The University of Sydney Engineering Technology Precinct Stage 1 - Modification 2

Changes to landscaping and flooding conditions

State Significant Development Modification Assessment

(SSD 8636 MOD 2)

Figure 4 | Proposed and existing planting and tree canopy coverage (Source: Modification 2)

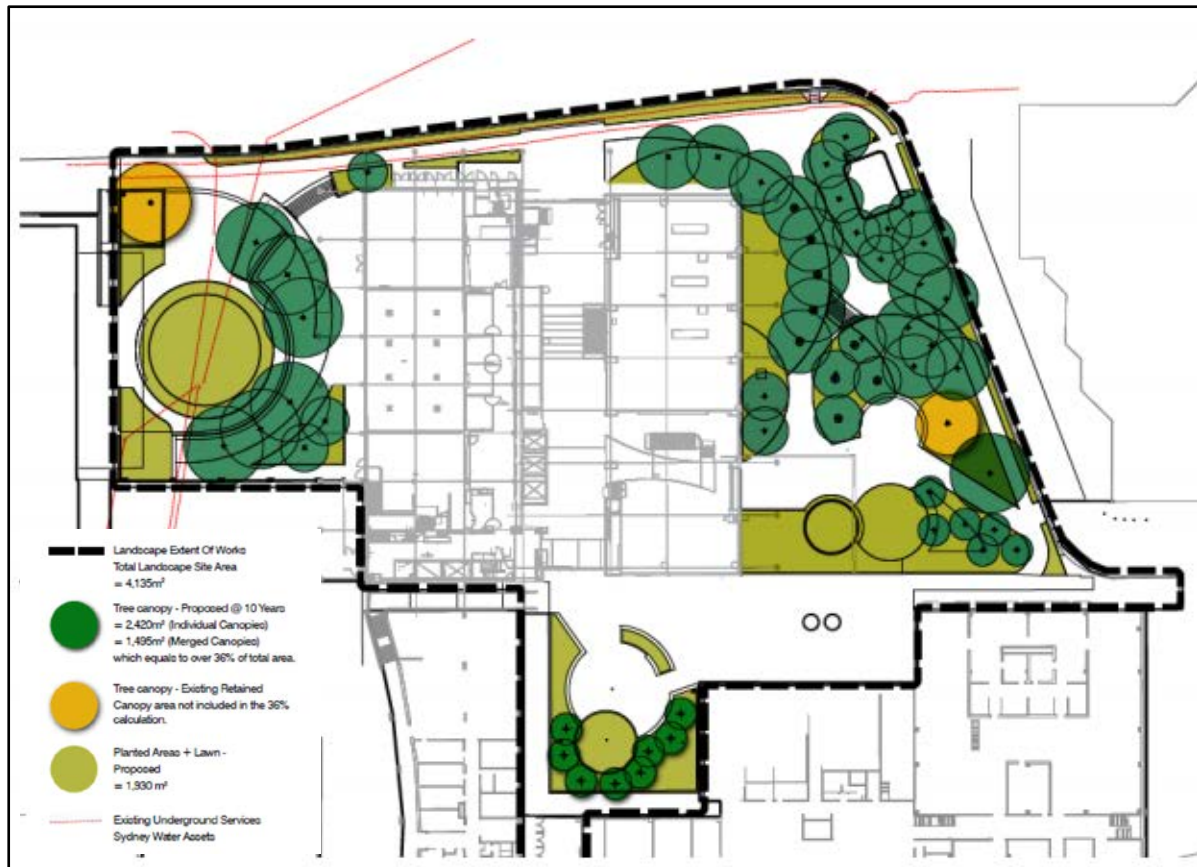
Council originally did not support the proposed landscape changes to layout, geometry, surface materials, and design quality of the plazas as they would dilute the approved indigenous strategy (Landscape design strategy prepared by TCL architects).

The Applicant responded to Council's concerns by stating that the proposed design would remain consistent with the original indigenous strategy (Wingara Mura) design principles and would provide a natural extension of the Cadigal Green constellation by providing circular designs, patterns, additional planting and less paving. The Applicant considered the new public domain design improved way finding and circulation across the site for persons with a disability and elderly people through the reduction of steps, simplified grading and a provision of a DDA compliant path network between buildings.

In considering the comments from Council and clarifications provided by the Applicant, the Department is satisfied that the proposed landscape changes remain considerate to the original design approach and would maintain compliance with the approved indigenous strategy through continued adoption of the Wingara Mura design principles.

Figure 5 | Southern Plaza approved (left) and proposed redesign (right) (Base source: Modification 2)

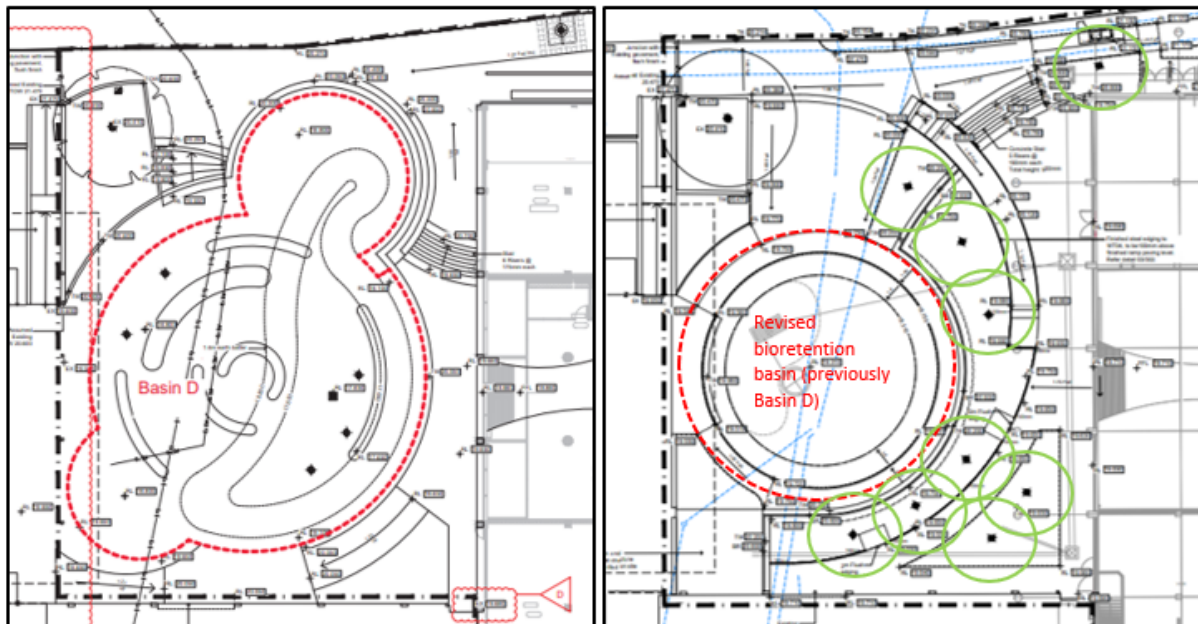
Council reviewed the proposed modification and noted that the Southern Plaza design would be altered significantly from the approved design and that the symmetry of the outdoor space would be changed from the approved indigenous strategy. Additionally, Council noted there was a reduction in planting from 10 trees to six and considered that planters on slab would provide inadequate soil depth to support healthy tree growth.

In response to Council's concerns, the Applicant confirmed that *Waterhousea floribunda* 'Amaroo' native trees are proposed to replace Paperbark trees (due to the unavailability of the latter and the associated myrtle rust issues). In addition, the compacted gravel around tree planting would be replaced with porous material (20mm rock mulch with no fines, allowing a max soil volume of 1.2m deep x 1.2m diameter) in accordance with Council's 'Landscape Code'. The final tree canopy is anticipated to achieve over 36 per cent coverage within 10 years of project completion, which would be in compliance with the 15 per cent requirement of the Sydney Development Control Plan 2012 (SDCP 2012). The Applicant also clarified there would be no tree planters on slab within the Southern Plaza.

The Department is satisfied that the design alterations and landscaping within the Southern Plaza would result in activation, connectivity and accessibility improvements. The planting alterations would provide adequate shading in summer and appropriate sunlight during winter achieving a comfortable pedestrian experience. Whilst the revised planting schedule does not meet all of Council's requirements, the Department has included conditions requiring revised mature planting, locating trees to allow full maturity and ongoing maintenance details to ensure suitable canopy cover and shading across the site. The Department also acknowledges that the redesign of the basin would continue to provide adequate flood detention capacity and protection to the buildings and its occupants.

Figure 6 | Approved Northern Plaza (left) and proposed redesign (right) (Base source: Modification 2)

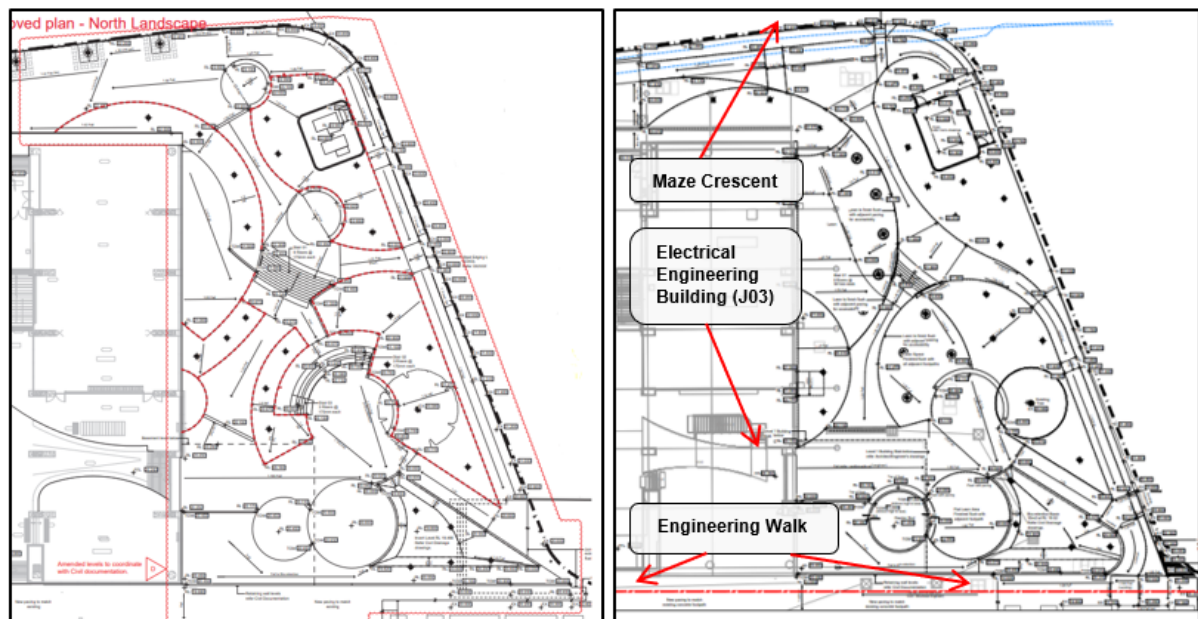
Within its submission on the modification application, Council recommended larger canopy trees (minimum mature height of 15m) be planted to achieve the 15 per cent canopy coverage required by the SDCP 2012. Council, in the comments on the Southern Plaza, noted the tree planters on slab would not provide adequate soil depth to support healthy tree growth.

In response to Council's concerns the Applicant's arborist confirmed that all nominated trees have the potential to achieve a 15m mature height with an accumulated canopy coverage of more than 36 per cent. Additionally, proposed trees would be either within a garden bed or on the lawn with a 1.2m soil depth as per **Figure 7**, highlighting sufficient planting depths would be provided.

Whilst the additional tree planting does not meet all of Council's recommendations, the Department has recommended a condition addressing Council's concern to ensure permeable surface surrounding trees.

The Department is satisfied that the landscape redesign of the Northern Plaza appropriately manages a balance between soft and hard surfaces by providing appropriate soil depth for tree growth and substantial canopy for shade, resulting in increased pedestrian comfort. Additionally, the improved accessibility and gathering spaces provided between areas is supported.

Figure 8 | View north of proposed awning (Source: Modification 2)

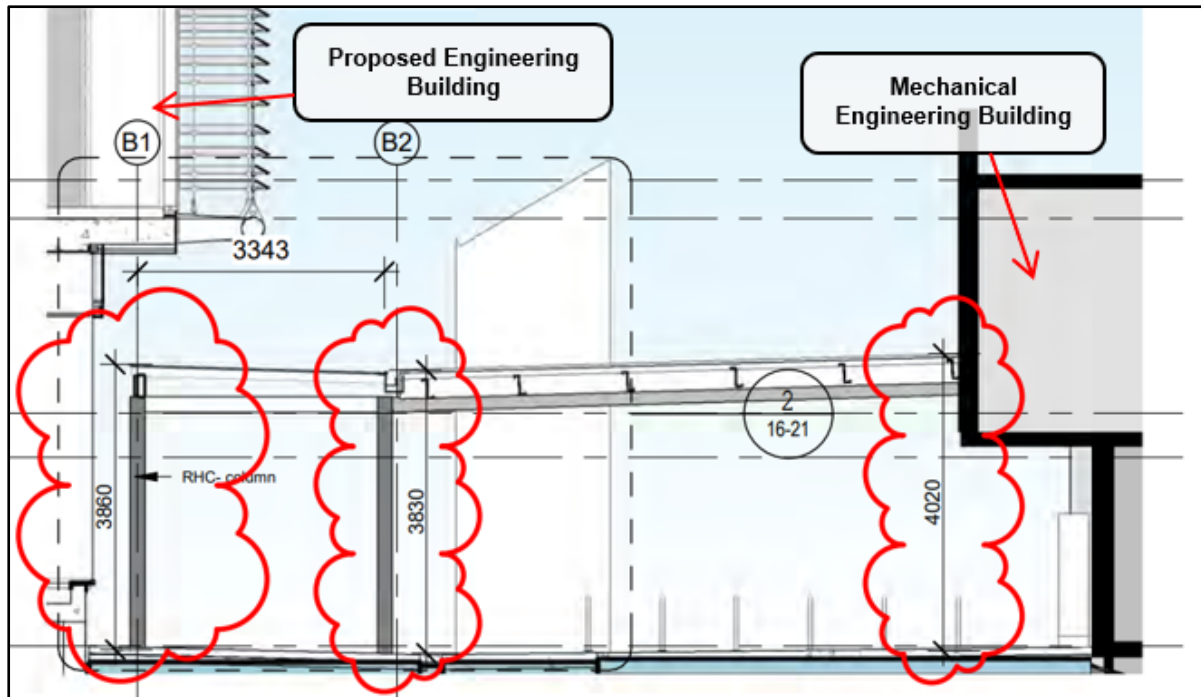
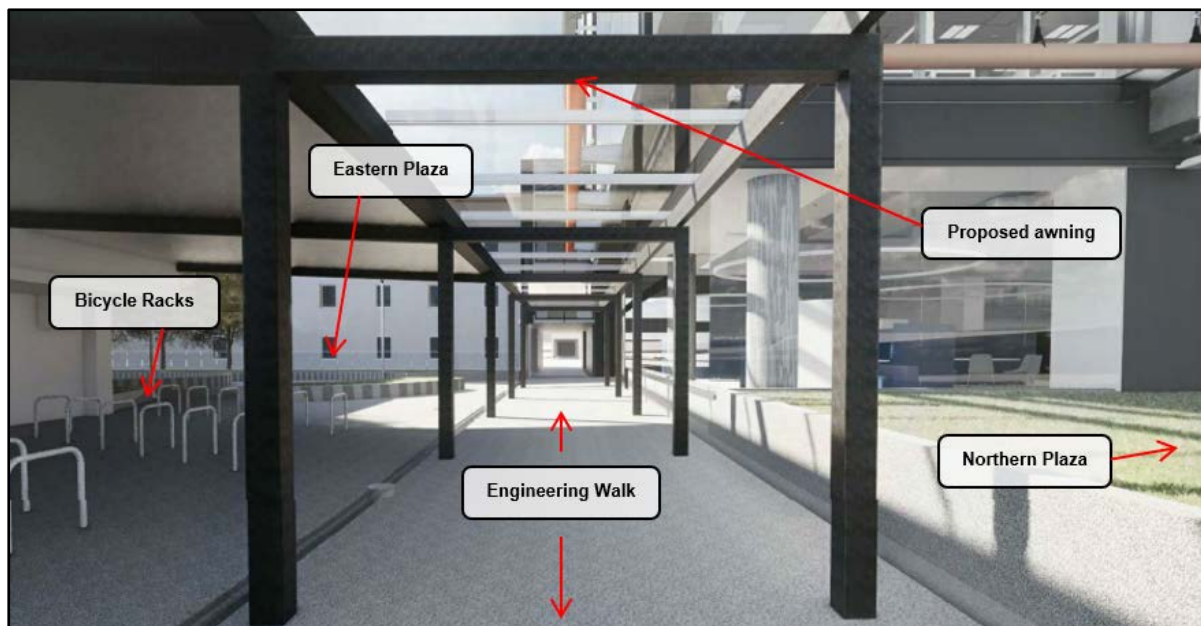
- the addition of a new glazed awning (3.5-4m high) to the Engineering Walk for users accessing the bike racks segregates the landscape area from the building.

- it is unclear if the seating walls within the Eastern Plaza would be accessible for students to sit and learn outdoors or whether it's non-usable space.

In response to Council's concerns, the Applicant confirmed that the Eastern Plaza would be an outdoor learning and social space with student access via the Engineering Walk, which connects all three plazas and provides access to the surrounding buildings, including the Engineering Building (J03), within the precinct.

The Department is satisfied that the design changes incorporating the awning within the Eastern Plaza, ground surface treatment changes and species substitution improve the pedestrian environment (i.e. seating and weather protection).

Figure 10 | Existing water and gas services (Source: Modification 2)

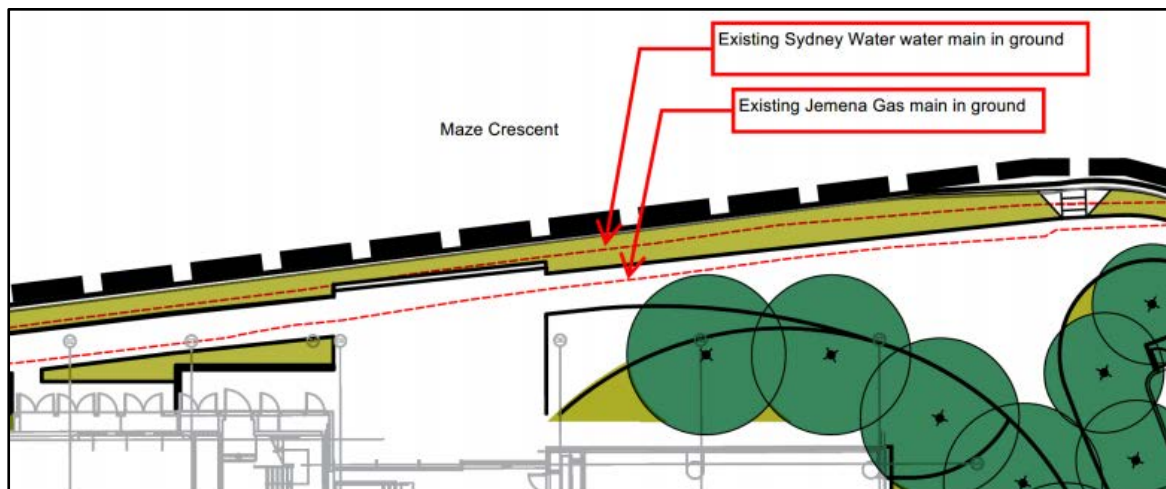
Council is not supportive of the deletion of these trees.

The Applicant has clarified that a Sydney Water and a Jemena gas main restrict the placement of trees along Maze Crescent (see **Figure 10**). The six trees along Maze Crescent are to be relocated, with four trees added to garden beds (and two trees within the Southern Plaza (see **Figure 11** yellow highlight).

The Department is satisfied that the proposed trees and garden beds along Maze Crescent would ensure underground services are not disturbed and the reduction in hard paved areas would enable increased soft landscaping and clear pathways enhancing the pedestrian experience through movement and visual interest.

Figure 12 | One per cent AEP flood level afflux – Proposed (Source: Modification 2)

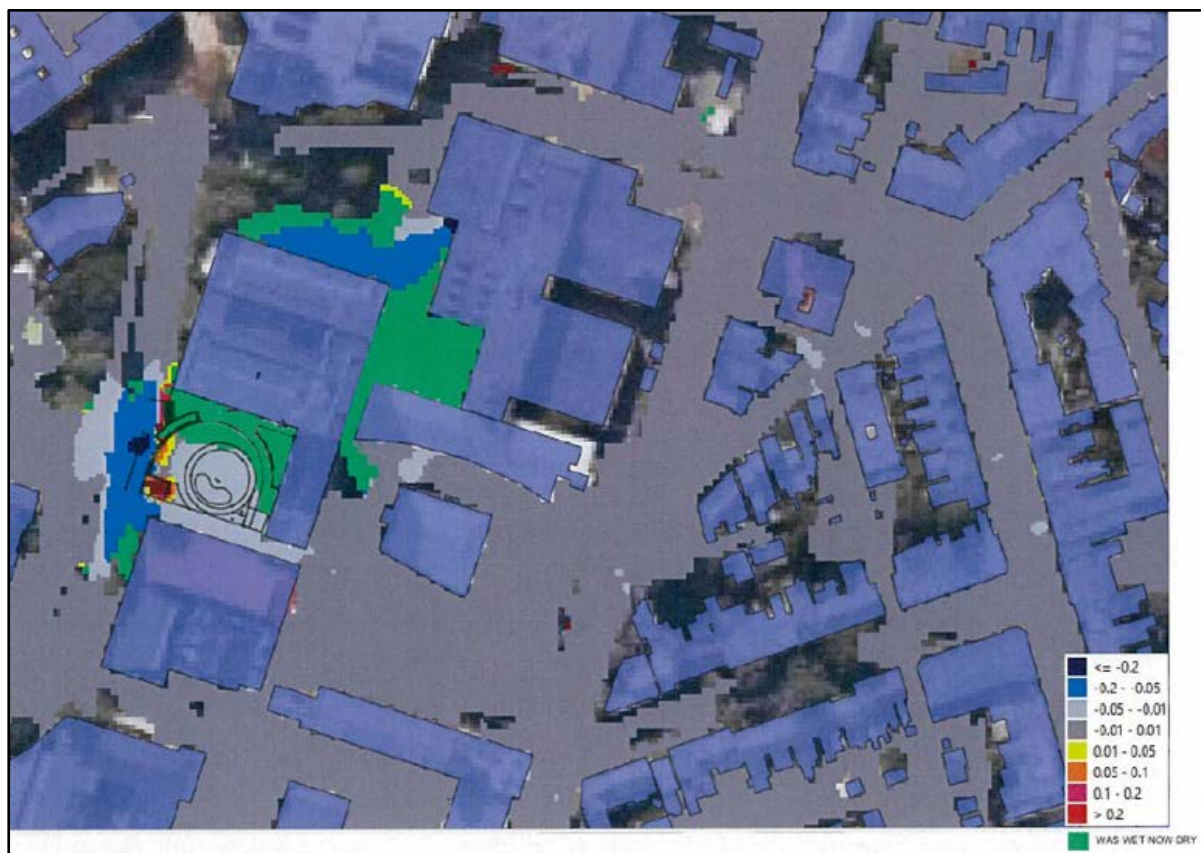
As such, the Applicant sought the removal of condition B36. Council's submission identified that new works that are likely to be immersed during a 100-year rainfall event need to comply and existing structures that remain need not comply. The Applicant accepted the condition be amended to reflect Council's submission.

In considering the Applicant's request and the comments from Council, the Department has recommended modifications to the condition to apply to new works given the proposal does not increase flood risk to existing structures.
